**Subject:** WRITTEN SUBMISSION: LETTER OF OBJECTION 231 Whale Beach Road  
Whale Beach 2107 REV 2021/0034

**231 Whale Beach Road Whale Beach 2107**  
**REV 2021/0034**

**Section 8.2(1A) Review of Determination - Review of Determination of Application DA2020/0442 for demolition works and construction of a Mixed-Use Development comprising Shop Top Housing and retail premises, with associated carparking, landscaping and strata subdivision**

*Marked-up Roof Plan: Zone in excess of 8.5m building height: the excessive height above 8.5m is not 'minor' and fails LEP 4.3 2D [a], and fails the objectives LEP 4.3 [1] [a] desired character of locality, [b] compatible with neighbours, [c] overshadowing, and [d] view.*

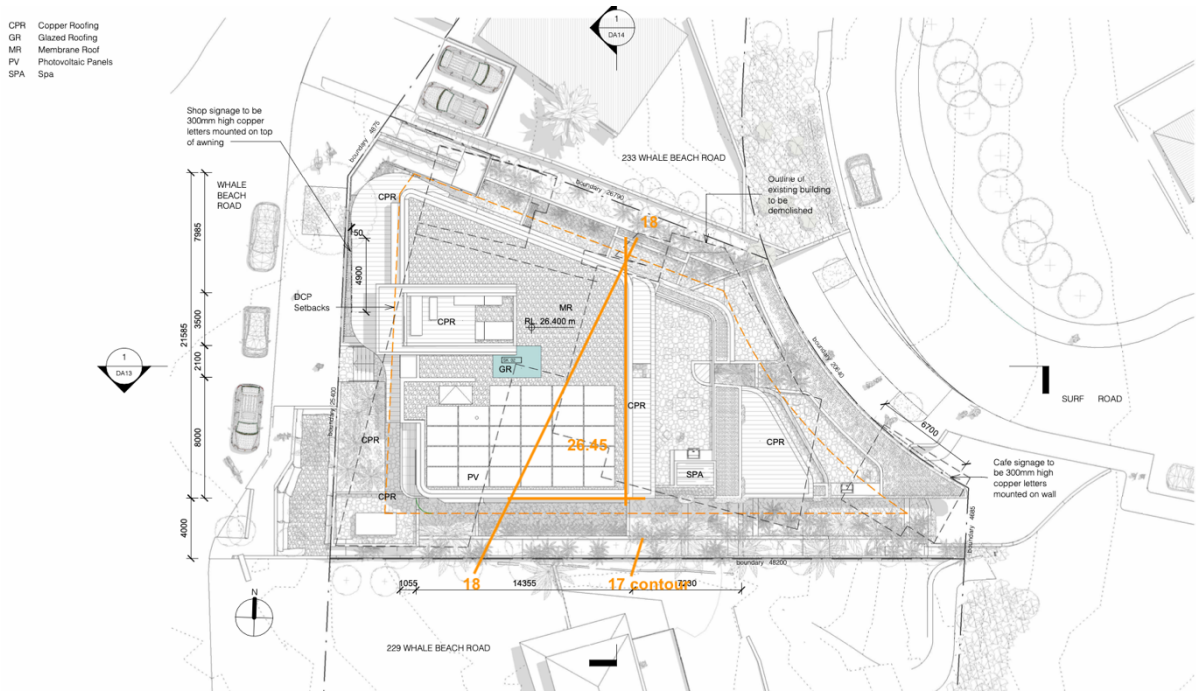
The south-east corner of the Level 4 is positioned well above the 8.5m building height, contrary to the Applicants drawings. The excessive height extends along the southern boundary at Level 4 by up to 8m in length, and extends across the entire eastern 16m edge of the proposed roof.

The excessive roof zone above 8.5m is a triangular section covering an area of c 65sqm of the south-east corner of Level 4. It is this zone that we contend is unacceptable.

We contend that the excessive height above 8.5m is not 'minor' and **fails LEP 4.3 2D [a]**, and fails the objectives **LEP 4.3 [1] [a] desired character of locality, [b] compatible with neighbours, [c] overshadowing, and [d] view.**

1. Lower the entire built form by 1m. Proposed south-east corner of the roof, sits adjacent to the RL 17.0 Contour. Reduce the Roof Parapet to RL 25.5 to maintain 8.5m building height. Alternatively remove the non-compliant zone above 8.5m building height by greater terracing and a reduced upper level floor plate.

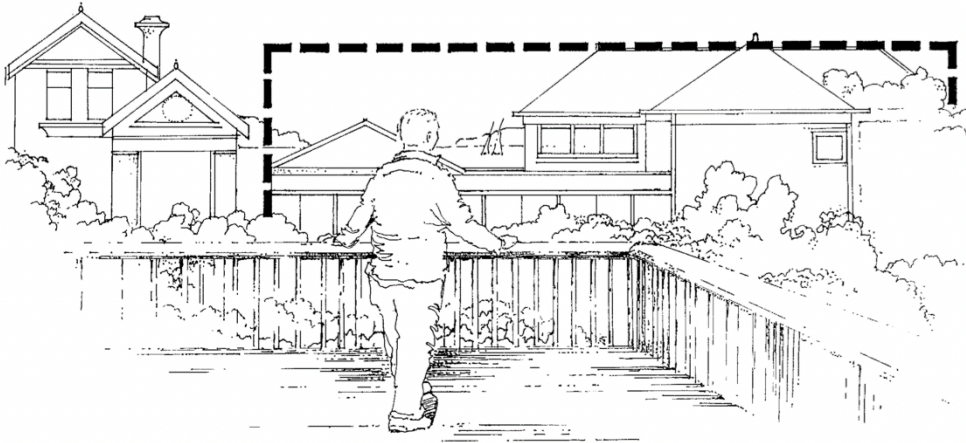
The private domain visual catchment is an arc to the east from which views will be affected as a result of the construction of the proposed development.

The proposed development will create view loss in relation to our property.

Having applied the tests in the Tenacity planning principle and without height poles erected, we conclude that we would be exposed to a moderate view loss.
